Nomad

SERVICE BULLETIN

SUBJECT: REVISION OF MAXIMUM CONTINUOUS POWER TURBINE
OUTLET TEMPERATURE

NMD-77-1
REVISION 1
Page 1 of 6

FIGURE 1

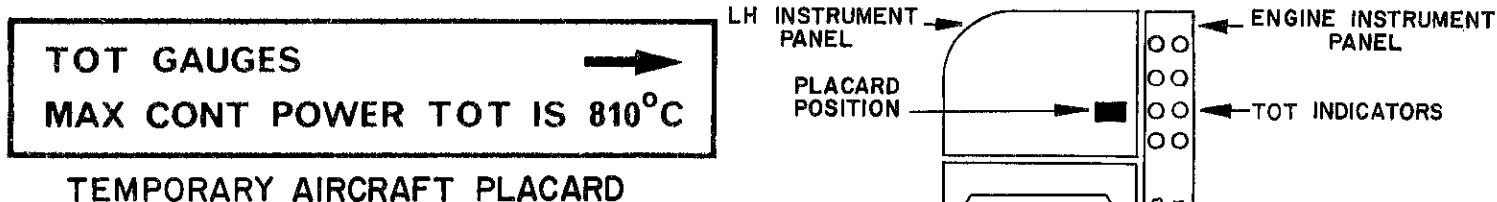
- (1) The temporary placard (Ref Figure 1) is to be locally made from suitable materials, e.g. thin white card and Letraset 12 Point Grotisque 216 Sheet 208 lettering, or embossing tape (Dymo or equivalent). Use template (Ref Figure 2) on Page 5 to assist in making the placard.
- (2) Attach the placard, using a contact adhesive to the LH instrument panel. The placard is to be located adjacent to the TOT indicators on the engine instrument panel.

Rework of TOT Indicator
Figure 3

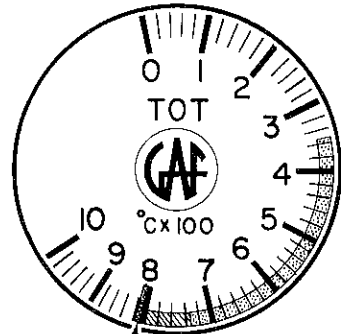
CAUTION: THE BLUE LINE MUST NOT BE PLACED OVER THE RED LIMIT MARKING AT THE 810°C POSITION (REFER FIGURE 3).

DELETE BLUE LINE AT 779°C

RED AND BLUE LINE AT 810°C
SAME SIZE AS EXISTING 100 MARKS

- b. Delete the blue radial limit marking at the 779°C position on the indicator dial by painting with instrument matt black paint or suitable equivalent.
- c. Restore full coverage of yellow band with yellow paint to Federal Standard 595 Colour No. 38907 where blue radial marking existed.
- d. Paint new blue radial at the 810°C position on indicator dial as shown on Figure 3.
